Facilities Plan Review Comments Response – Wastewater Collection and WWTF Dekorra Utility District No. 1, Town of Dekorra, Columbia County, WI

GEC #1297-89a

Facilities Plan Review - 2/28/05 DNR Planning Comments Response

EXHIBIT 2-2
2003	DEKORRA UTILITY DISTRICT NO. 1 BOUNDARY MAP
	District boundary remains the same as in 1998 however the District is in
process of upgradin	ng the boundary to meet the needs of the proposed development scenar

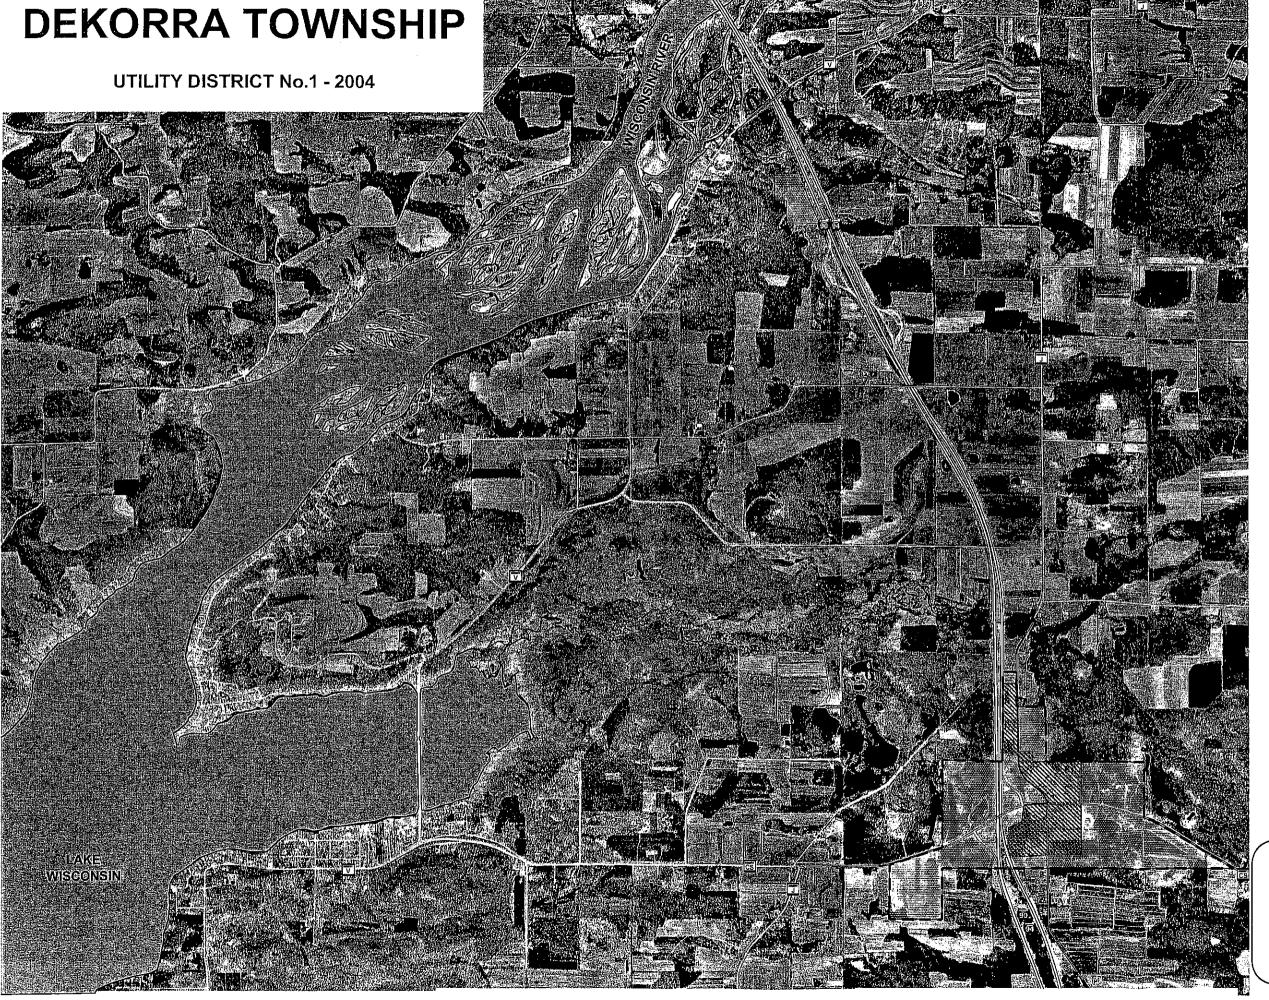
The Utility District has been officially set to match Exhibit 2-1 in our January 20th response packet. The Utility District is in the process of having a boundary description prepared by a local surveying company.
